UNITED STATES PATENT AND TRADEMARK OFFICE

APPLICATION NO.	FILING DATE	FIRST NAMED INVENTOR	ATTORNEY DOCKET NO.	CONFIRMATION NO.
10/719,962	11/24/2003	Virginia Shade	WFL 186	3580
34356	7590	01/24/2005	EXAMINER	
ASHKAN NAJAFI, P.A. 6817 SOUTHPOINT PARKWAY SUITE 2301 JACKSONVILLE, FL 32216			HOEY, ALISSA L	
			ART UNIT	PAPER NUMBER
			3765

<b>Office Action Summary</b>	<b>Application No.</b>	<b>Applicant(s)</b>	
	10/719,962	SHADE, VIRGINIA	
	<b>Examiner</b>	<b>Art Unit</b>	
	Alissa L. Hoey	3765

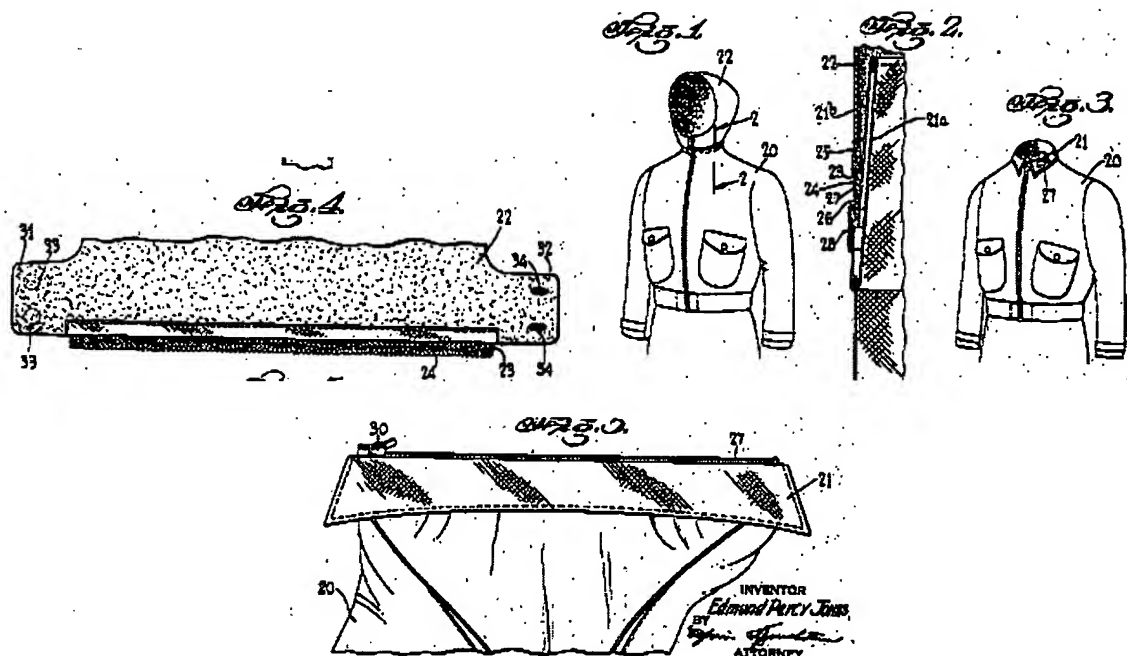
1. This is in response to amendment submitted 11/05/04. Claims 1, 5, 7, 10, 12 and 15 have been amended. Please note that claim 12 was amended and has been labeled as "(Original)". Drawing changes and specification amendments have been entered. Please note that the drawing objections from office action sent 08/05/04 have not been addressed with regard to figures 5 and 6. Claims 1-15 have been finally rejected below.

2. The drawings are objected to under 37 CFR 1.83(a). The drawings must show every feature of the invention specified in the claims. Therefore, the flap portion in figures 5 and 6 must be shown or the feature(s) canceled from the claim(s). No new matter should be entered.

In figure 5 and 6 the collar receiving portion (12) is shown to fold over the fastener means (40). If this is true, then how does the flap (20) fold over the top edge of the fastening means and the top edge portion of the body garment as required in claims 1, 10 and 15.

Corrected drawing sheets are required in reply to the Office action to avoid abandonment of the application. Any amended replacement drawing sheet should include all of the figures appearing on the immediate prior version of the sheet, even if only one figure is being amended. The figure or figure number of an amended drawing should not be labeled as "amended." If a drawing figure is to be canceled, the appropriate figure must be removed from the replacement sheet, and where necessary, the remaining figures must be renumbered and appropriate changes made to the brief description of the several views of the drawings for consistency. Additional replacement sheets may be necessary to show the renumbering of the remaining figures. The replacement sheet(s) should be labeled "Replacement Sheet" in the page header (as
